**ORINATION FORM**

**Proposed Revisions to a Standard Plans Index**

Index Number: 700-010  
Sheet Number (s): 5  
Index Title: Single Column Ground Signs

Change minimum Driven Post Hole Diameter to 12" min; Added new Note 2 to allow for a square option.

DRIVEN POST DETAIL  
(Frangible Post In Through Sidewalk Installations without Sidewalk Similar)

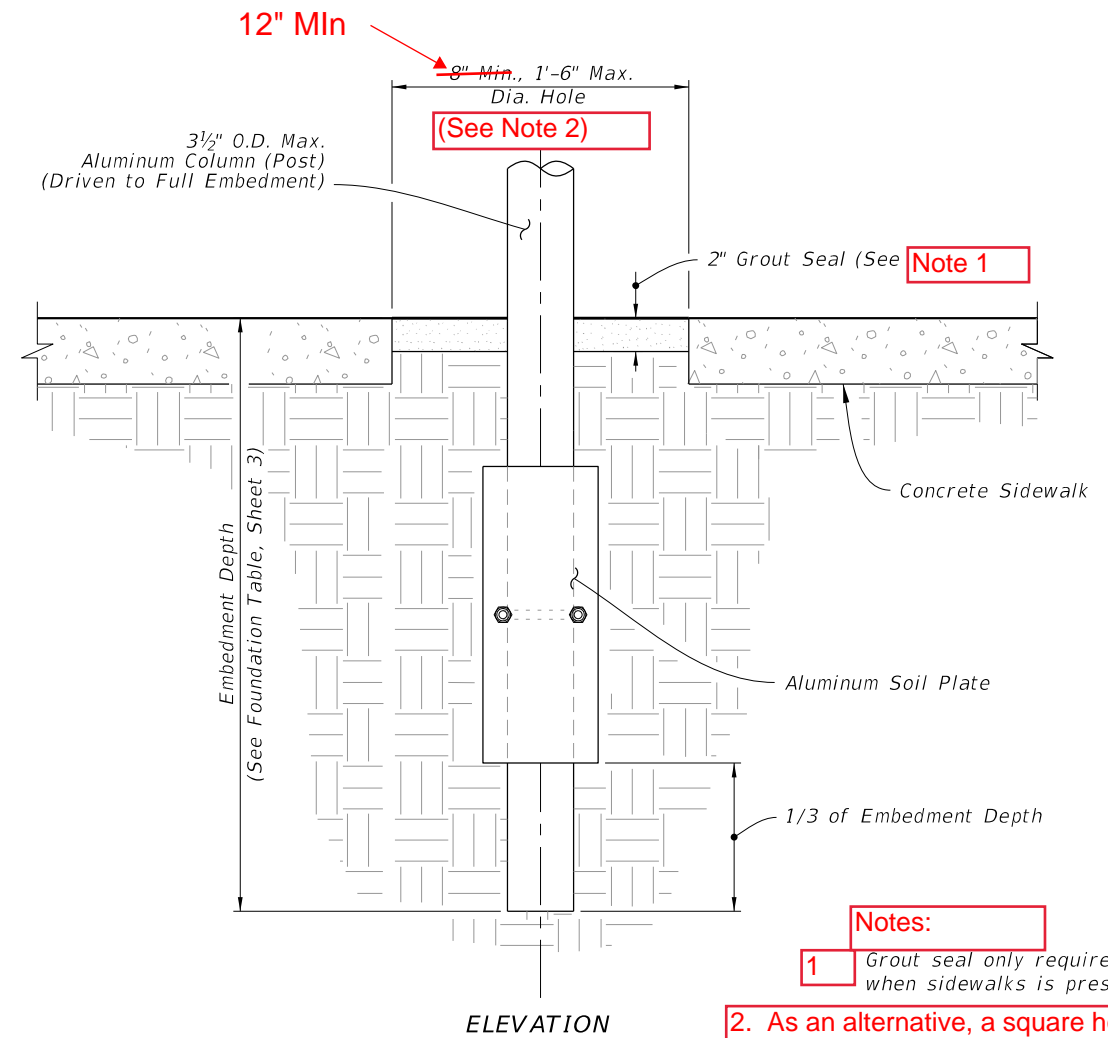
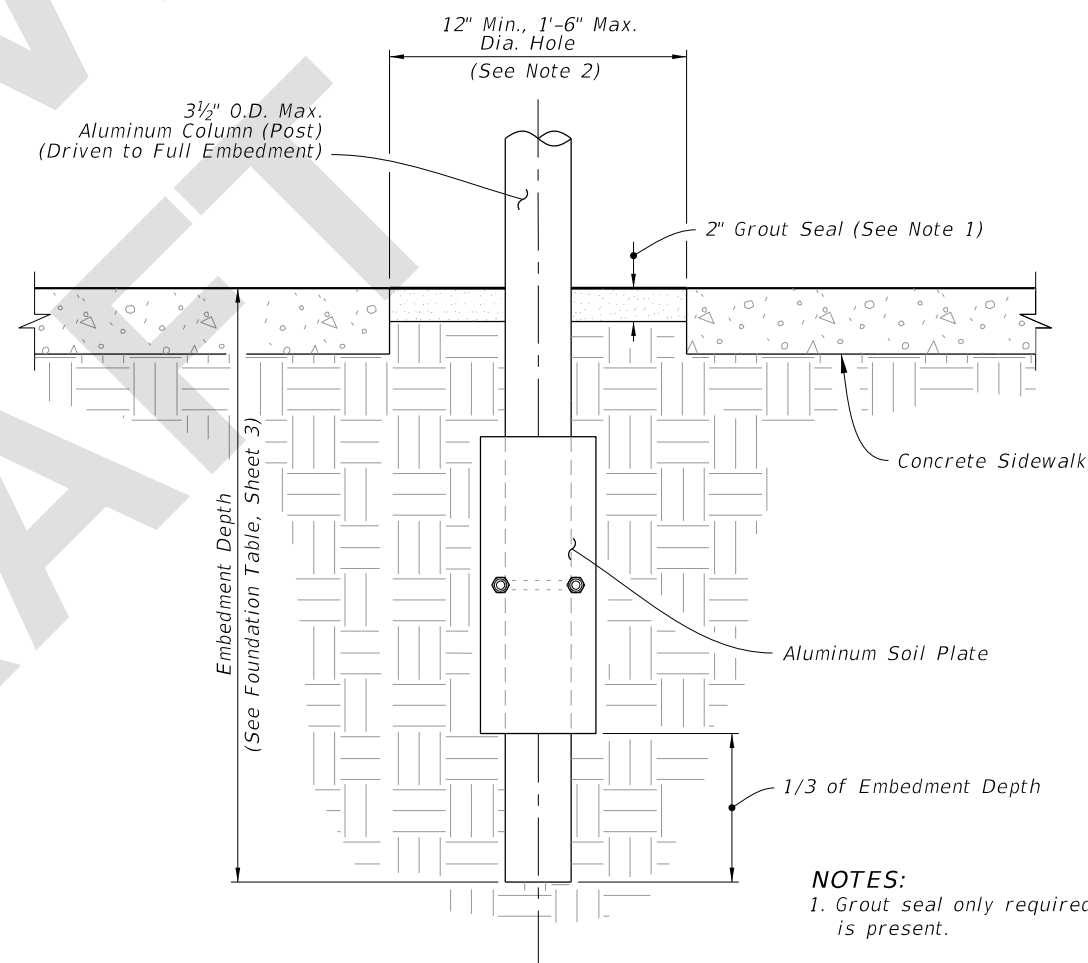
This change was requested by D7 Operations and coordinated with CO Maintenance and Construction. The 8" hole does not allow adequate space to remove old columns for replacement. Per a comment submitted by Industry, CO Maintenance requested that a square hole option be added.

- Notes:
- 1 Grout seal only required when sidewalks is present.
  2. As an alternative, a square hole may be used. The dimensions would remain, 12" minimum and 18" maximum.

**NOTES:**  
1. Grout seal only required when sidewalks is present.  
2. As an alternative, a square hole may be used. The dimensions would remain, 12" minimum and 18" maximum.
